Safety Service Note

Supersedes: E4980A-02C-S

E4980A Precision LCR Meter, 20 Hz to 2 MHz

POSSIBLE "SHOCK PINCH" HAZARD

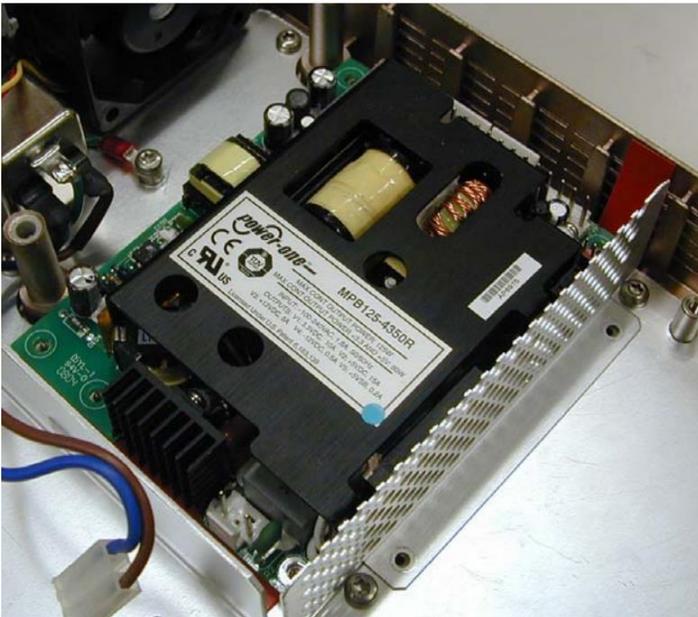
Install an insulator (FILM, p/n E4980-25005) in the E4980A

Step2. Put the insulator on base plate as shown in the figure below

Step3. Place the power supply on the insulator. After fastening the power supply, remove the film of adhesive tape of the insulator. Then, fasten ANGLE SHIELD (E4980-01205) and stick the adhesive part of the insulator to the ANGLE SHIELD

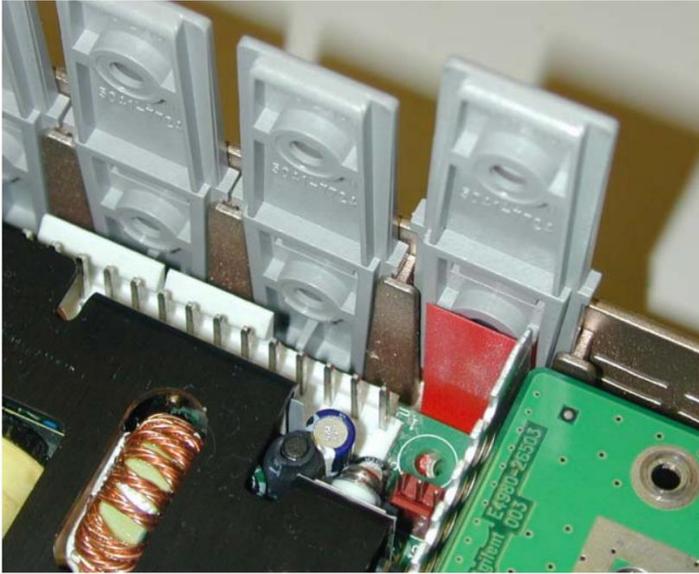
Step4. Reverse the order of the removal procedure. When installing the vent blocks, the confirmation tab of the

insulator is set internally in the vent blocks.

Step5. Check whether the insulator is placed correctly. Look at the inside through the hole of the right-side wall of the chassis with a flashlight. You can find the red color tab.

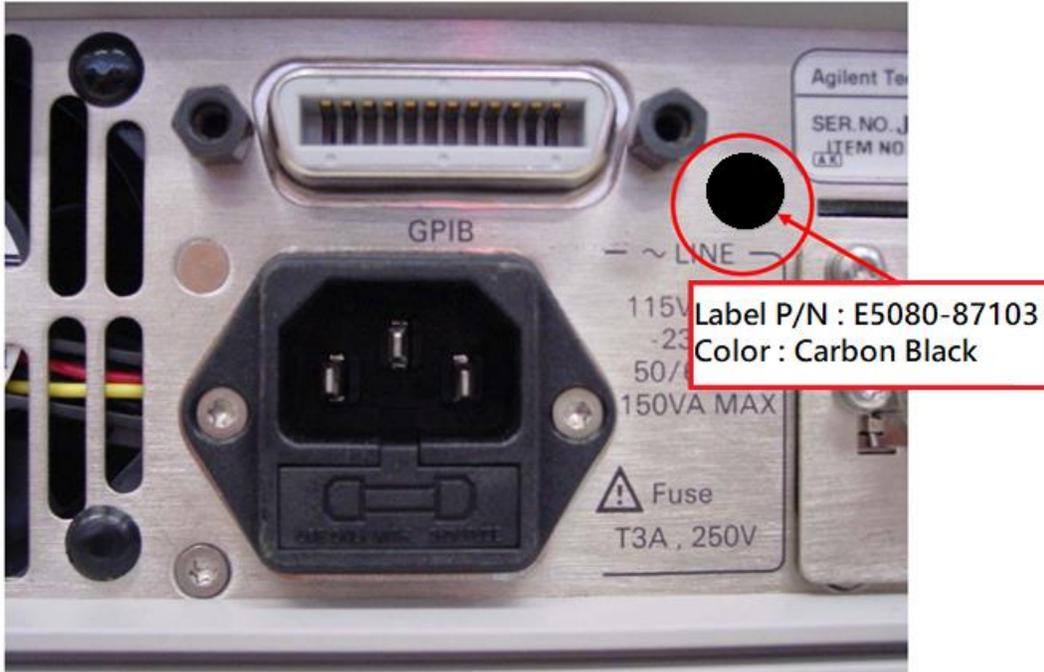
Step8. Stick a label (P/N E5080-87103) between AC Inlet and Serial Number Label. See the place below
